MDI Return Loss (part 1)

Gerrit den Besten

NXP Semiconductors

MDI Return Loss Comparison BASE-T1

Proposal visualized

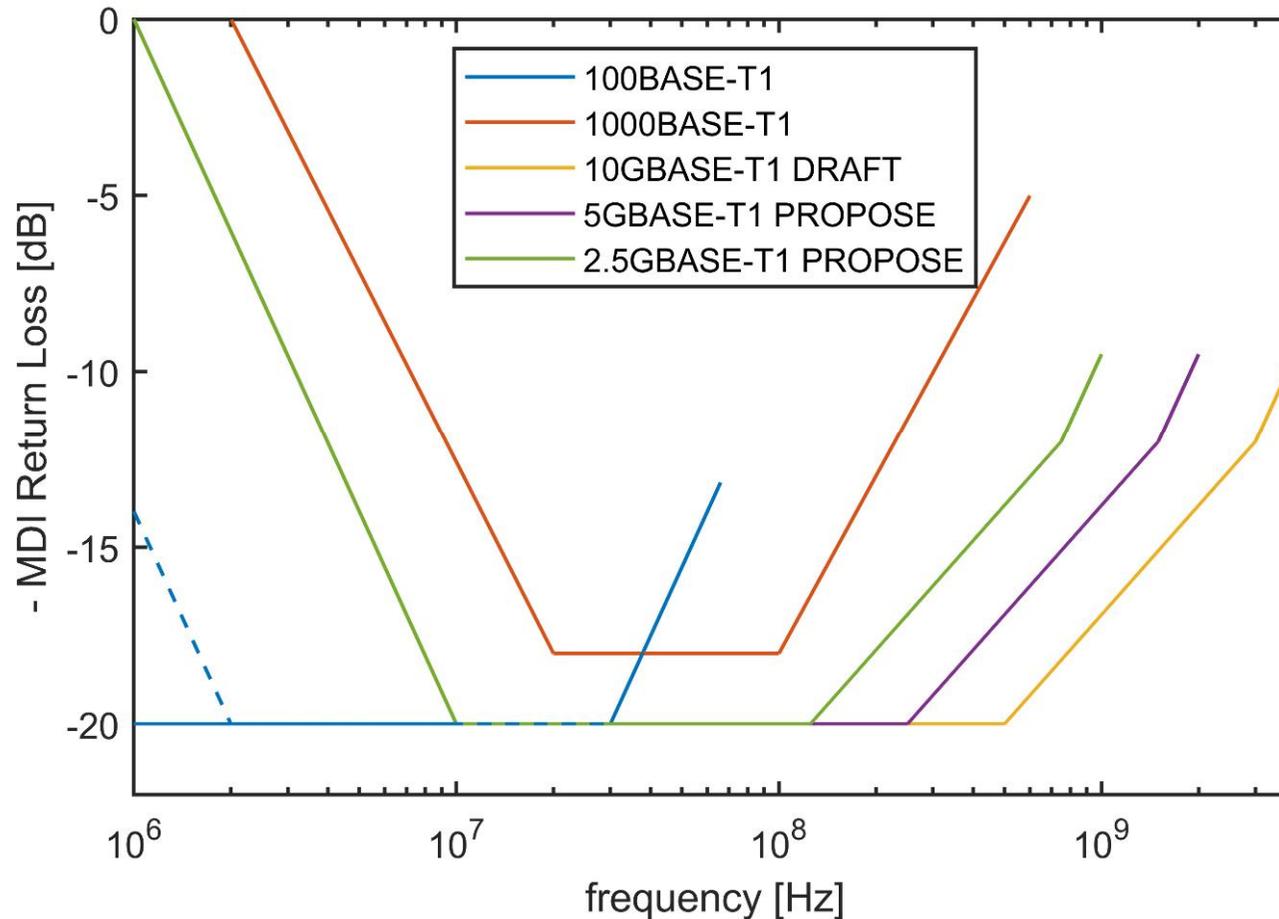
- ▶ 2.5GBASE-T1 >2x tighter than 1GBASE-T1, so sufficient

- ▶ Keeping lower corner at 10MHz
 - comment shows incorrectly an S-scaling there too

Comparing high frequency limit

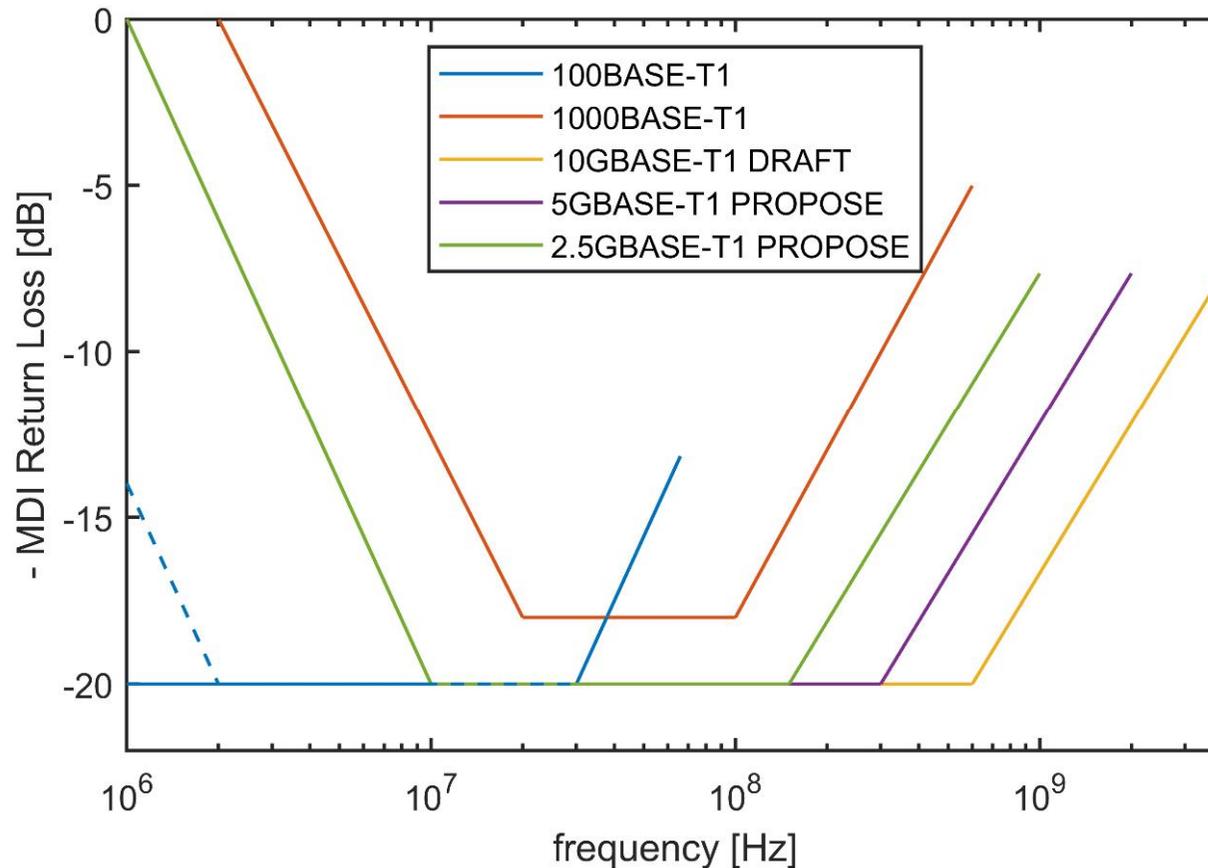
► Dual slope limit line

- ▶ The limit for the high-frequency seems tighter than necessary
 - Relatively much tighter than for 1000BASE-T1
- ▶ MDI return loss is far-end return loss, which gets twice attenuated by insertion loss
 - Worst $IL^2 * RL / IL$ for a low-loss link, improving for higher IL
 - In contrast to link segment return loss, with worst RL/IL for high IL
- ▶ PoDL experts have been driving this spec items so far, but PoDL is not the only reason for MDI return loss degradation
- ▶ What is the reason for the dual-slope in the HF roll-up?
 - Why not make a single slope roll-up like for the other speeds?

Example with single slope

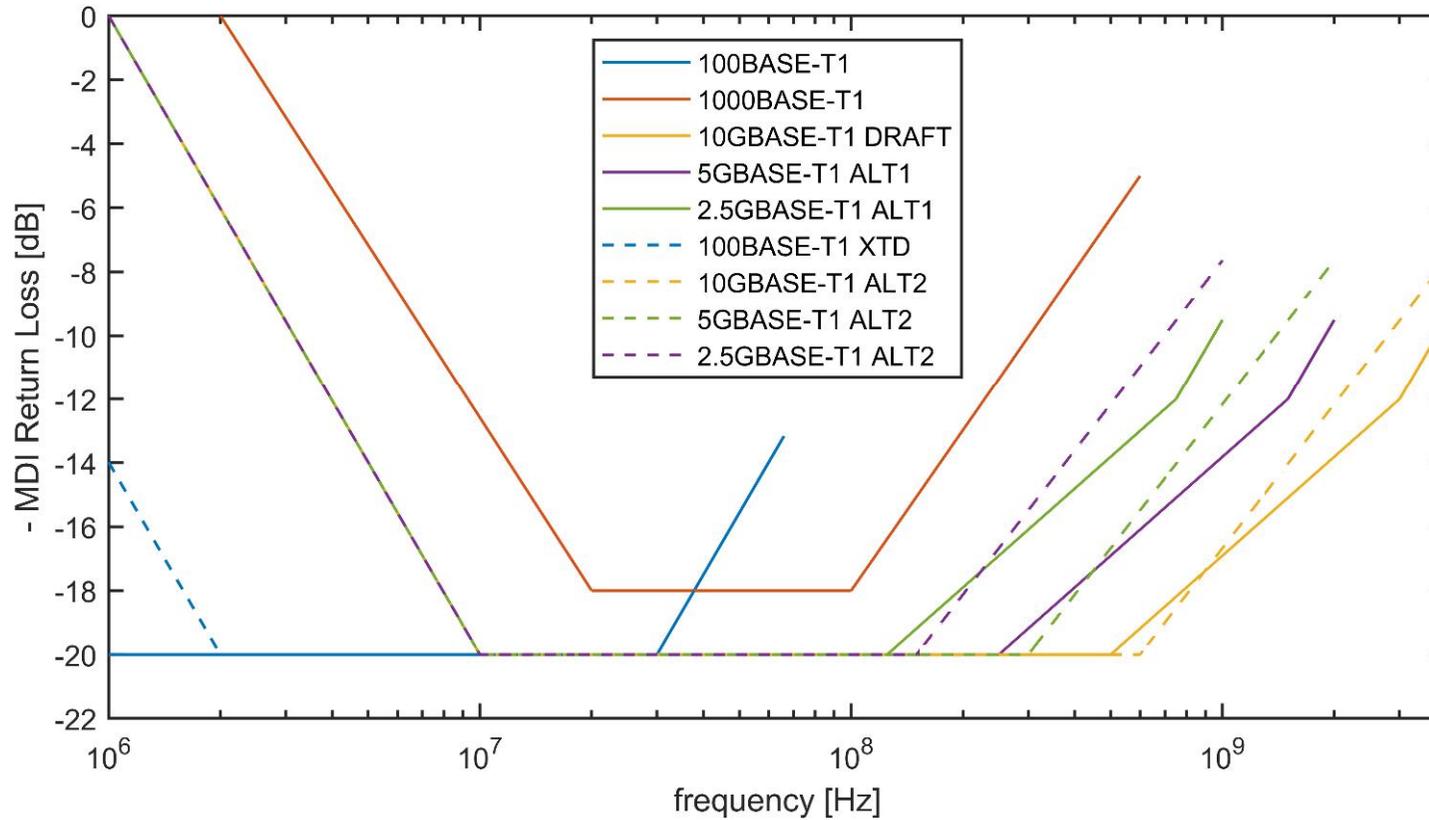
- ▶ $F > 600S \rightarrow RL_{MDI} = 20 - 15 \cdot \log_{10}(freq/600S)$
- ▶ $\sim 10\text{dB}$ at Nyquist $\rightarrow \sim 750\text{ fF}$ for 5.625GBd
